ADDRESS: 1108 S FRONT ST

Proposal: Legalize addition, roof deck, and other unpermitted work Review Requested: Final Approval Owner: Lauren Revak Applicant: William Klotz, Restoration Specialist Inc. History: Built early 19th century Individual Designation: 3/30/1965 District Designation: None Staff Contact: Ted Maust, theodore.maust@phila.gov

SCOPE OF WORK:

1108 5 Front St first floor
DRAWINGS PROVIDED BY: WK Com Liberty Design Build Registration # 056430
4/7/2024
SCALE: 1/4" = 1'
SHEET:
A -1

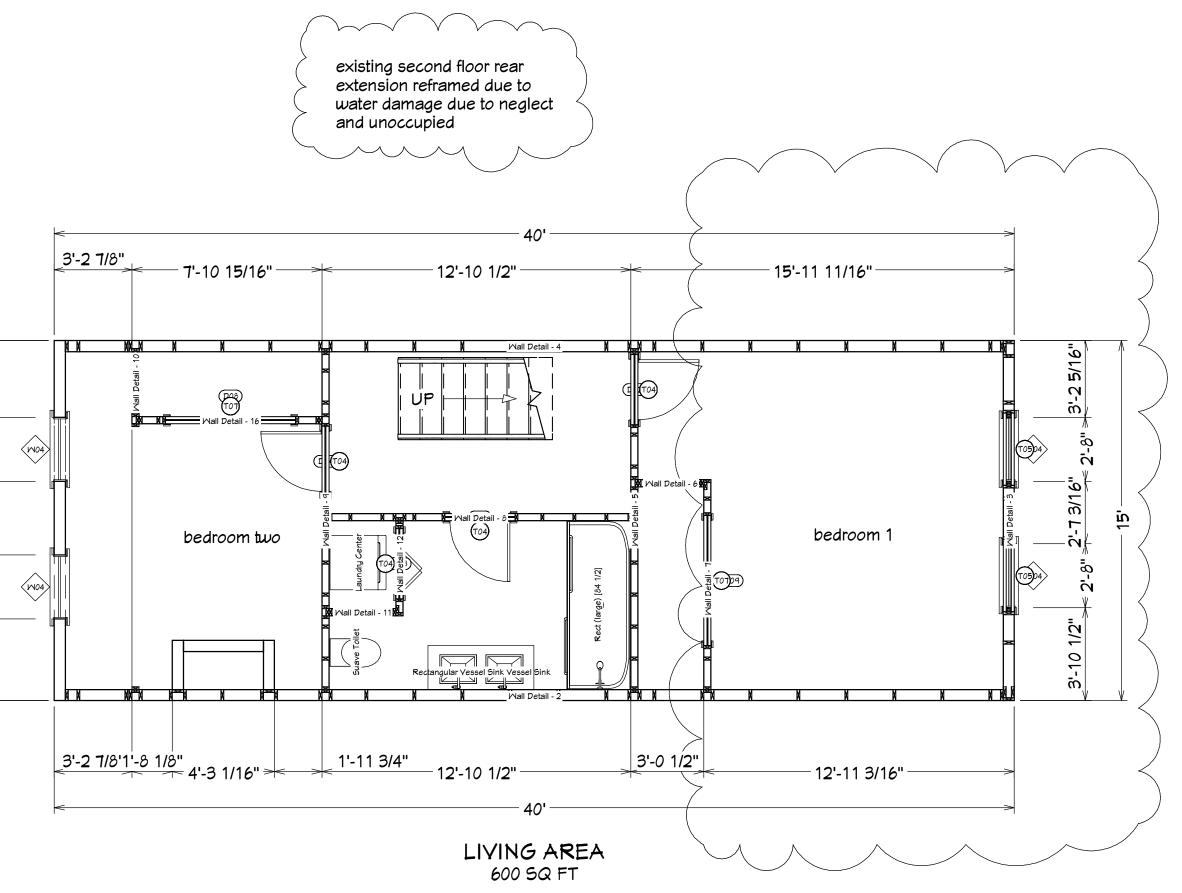
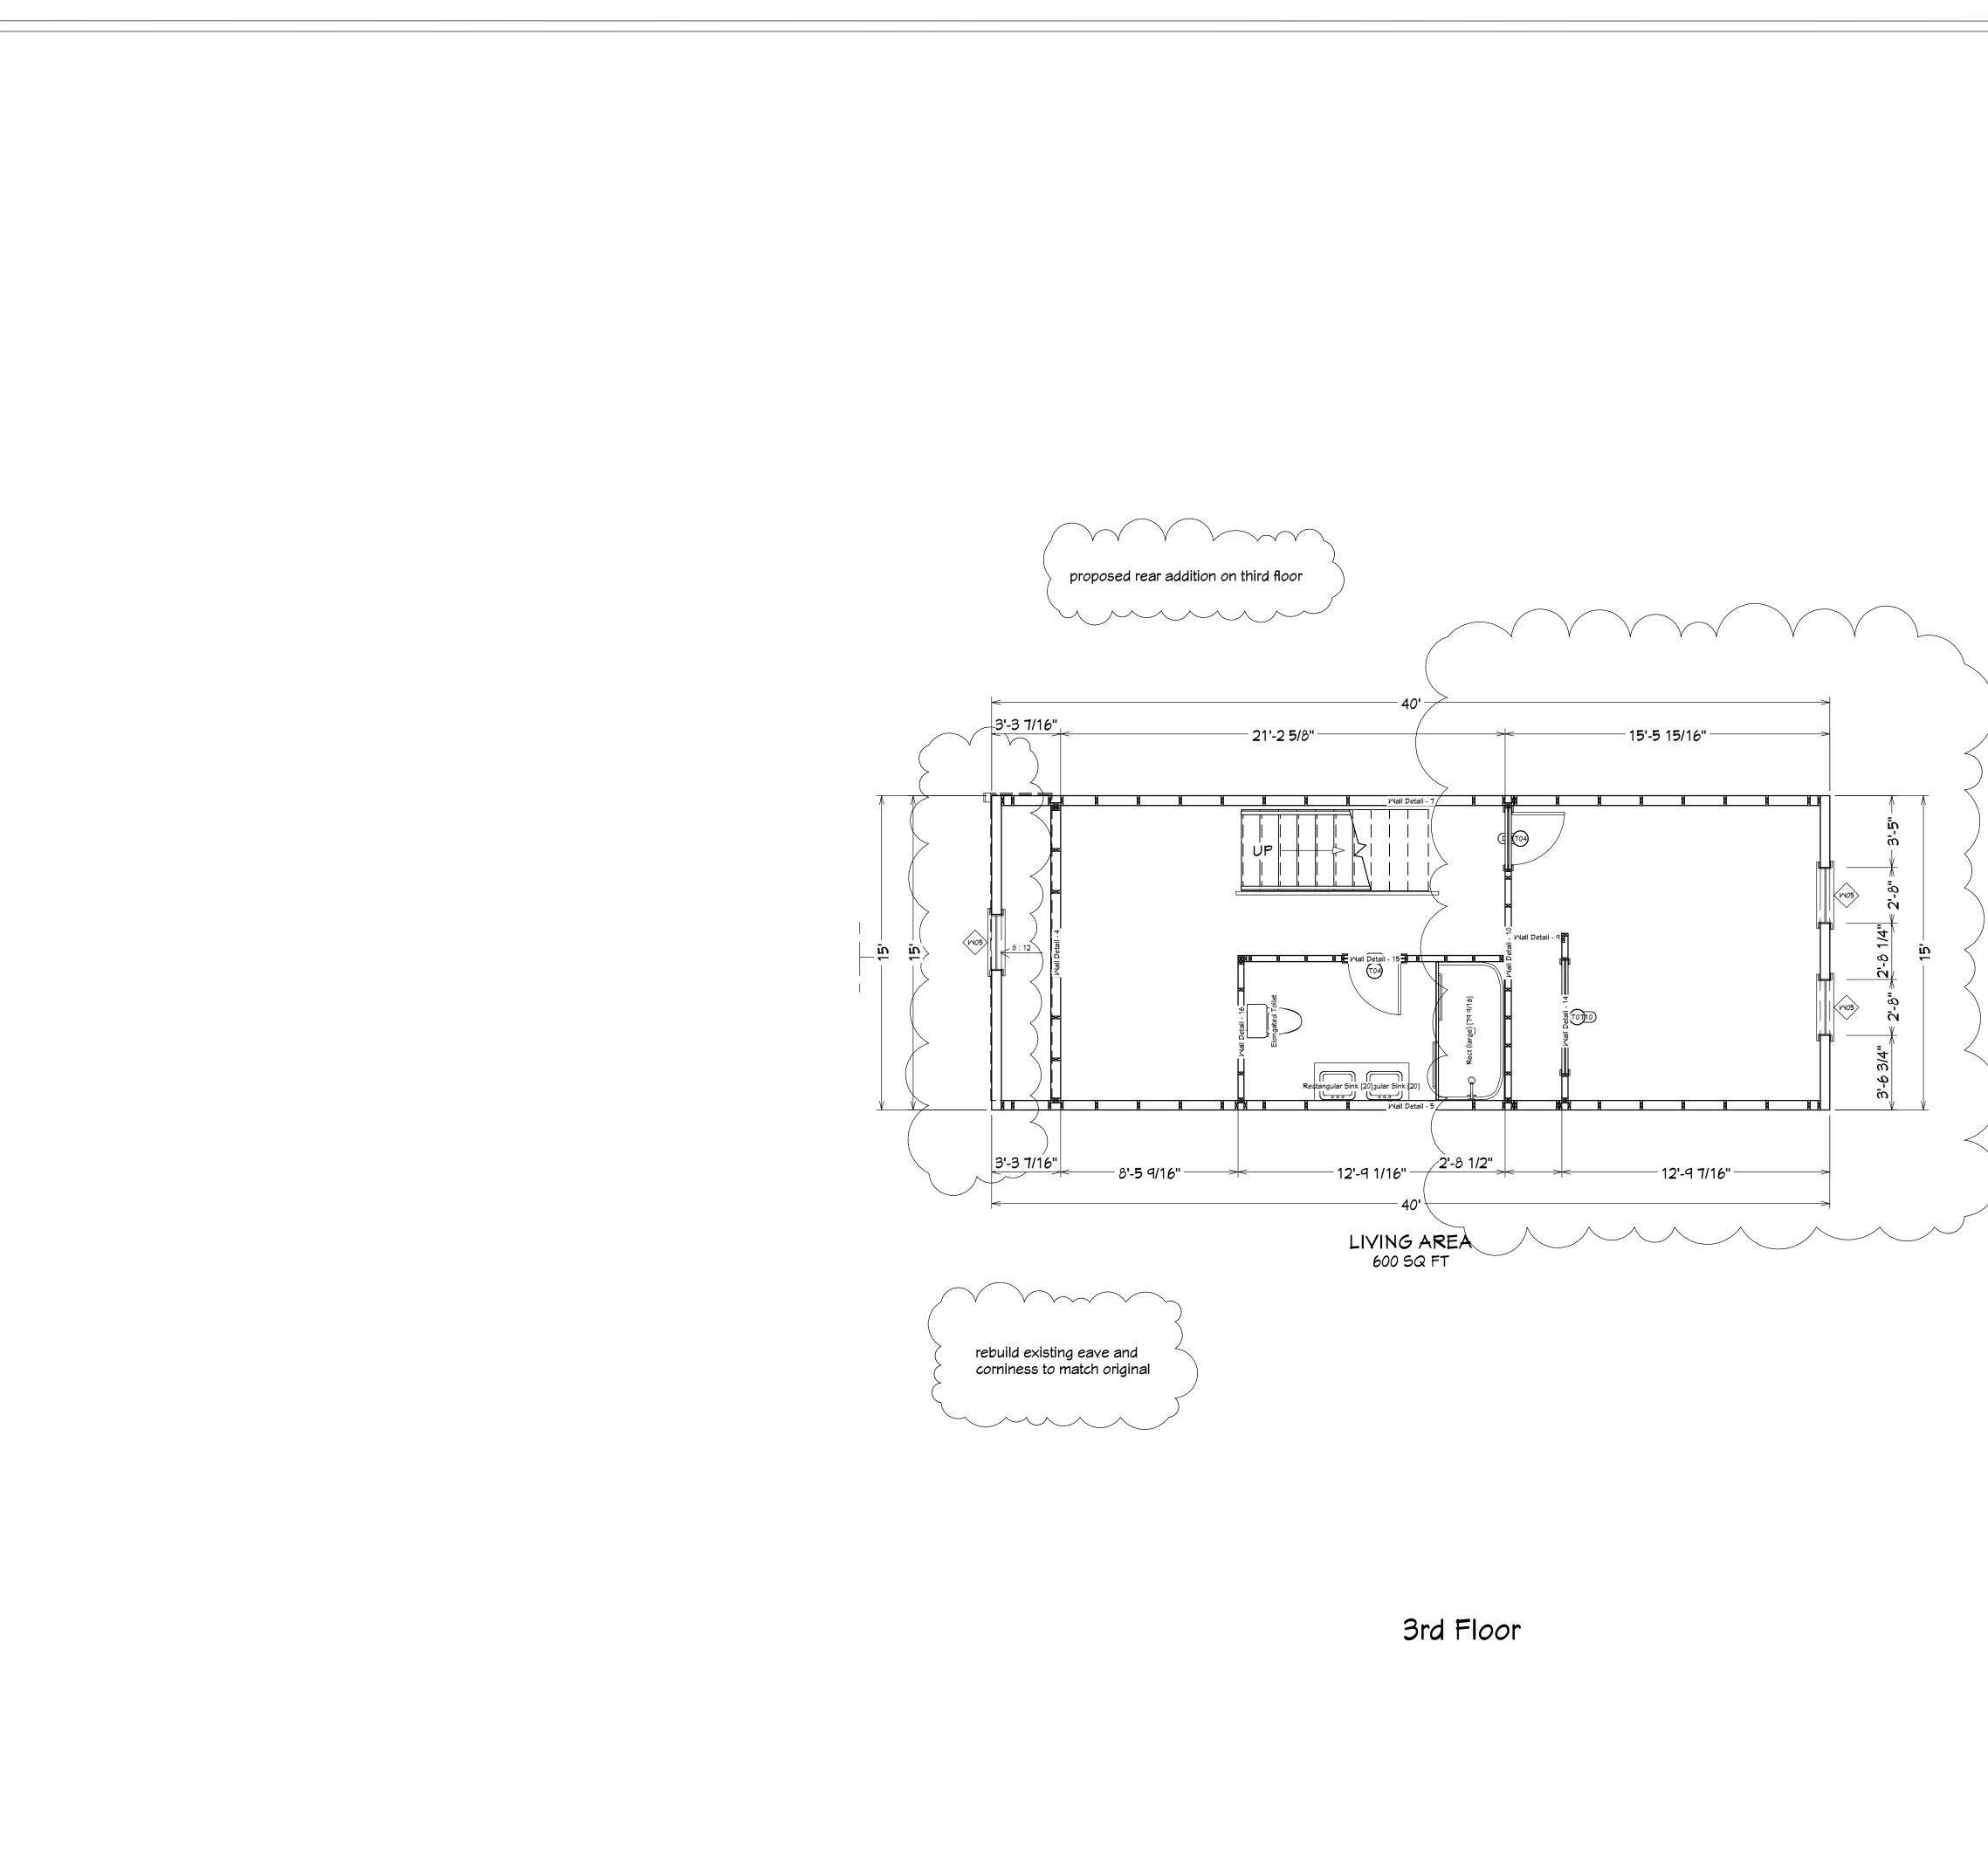
- From the submitted floor plans, it appears that at least some of the existing rear walls were demolished without the Historical Commission's approval.

1108 5 Front St roof deck
DRAWINGS PROVIDED BY: WK Com Liberty Design Build Registration # 056430
DATE: 4/7/2024 SCALE: 1/4" = 1' SHEET:
A - 4

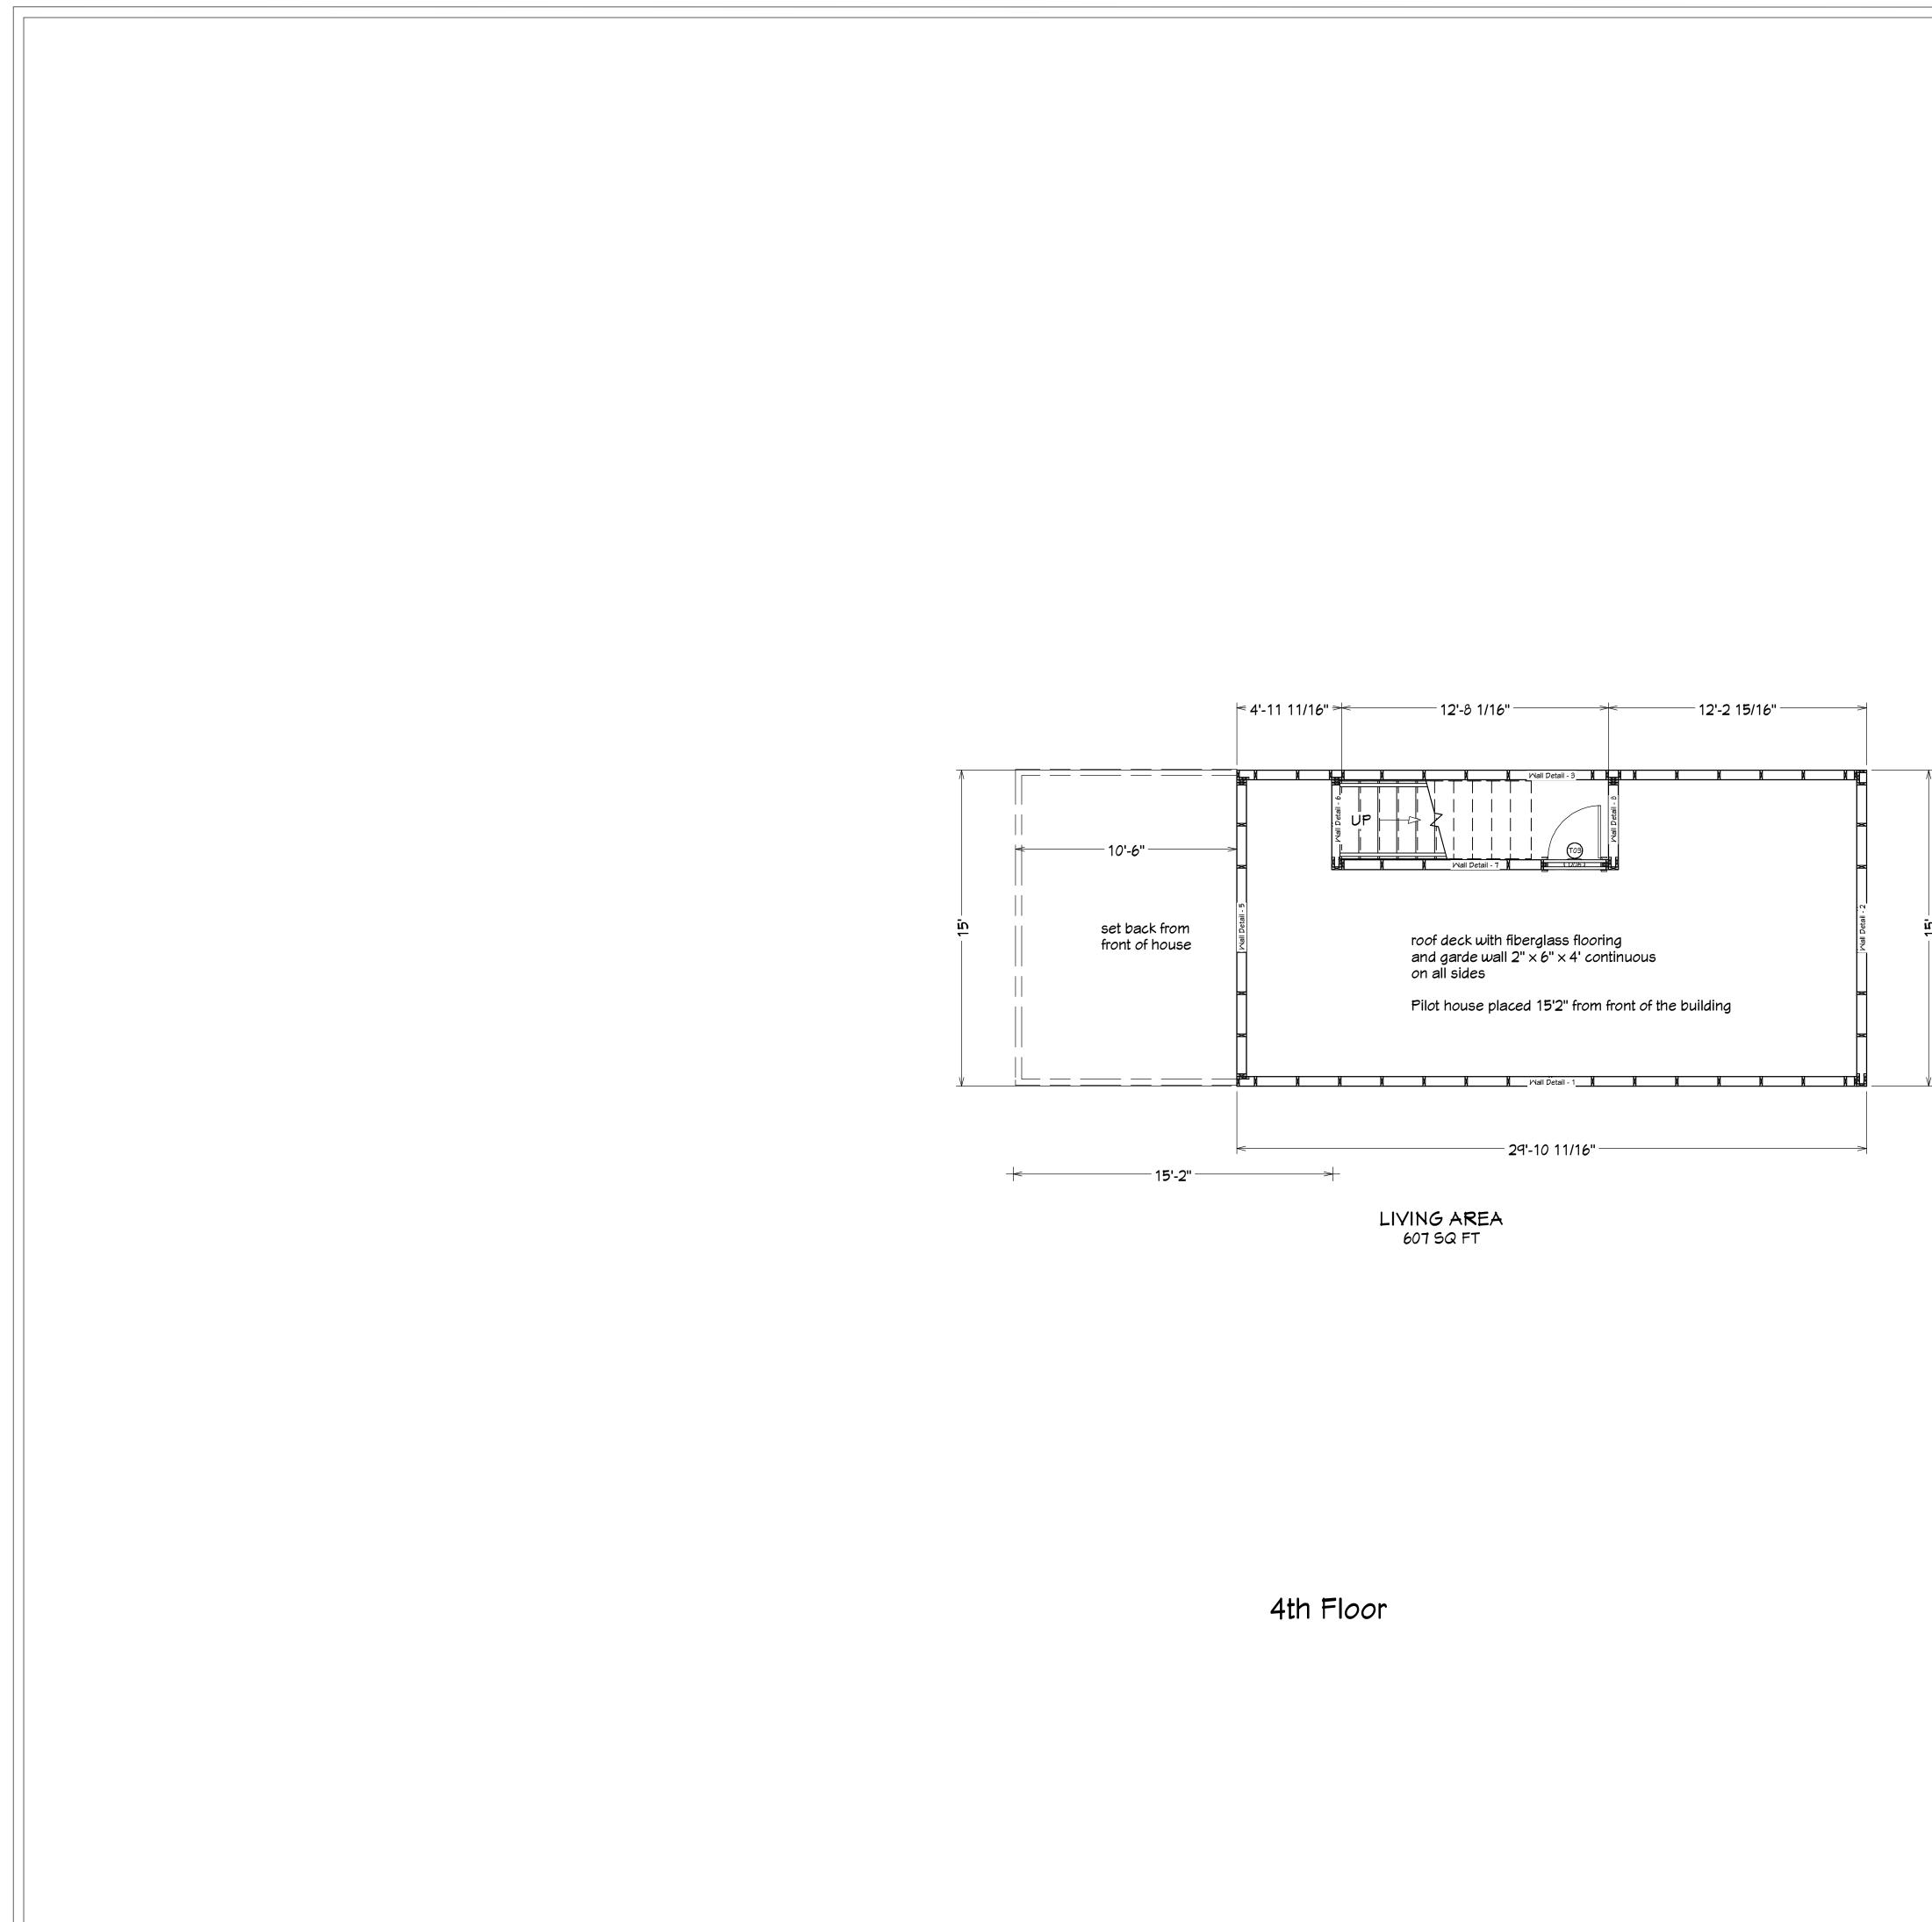
- The rear addition is very large in comparison to the historic structure. The roof deck and pilot house are very visible from the public right-of-way and change the established spatial relationships of the property.

- A two-story addition with a roof deck on the rear ell rather than the main block may be able to satisfy this Standard.
- Standard 10: New additions and adjacent or related new construction will be undertaken in such a manner that, if removed in the future, the essential form and integrity of the historic property and its environment would be unimpaired.

STAFF RECOMMENDATION: Denial, pursuant to Standards 9 and 10.
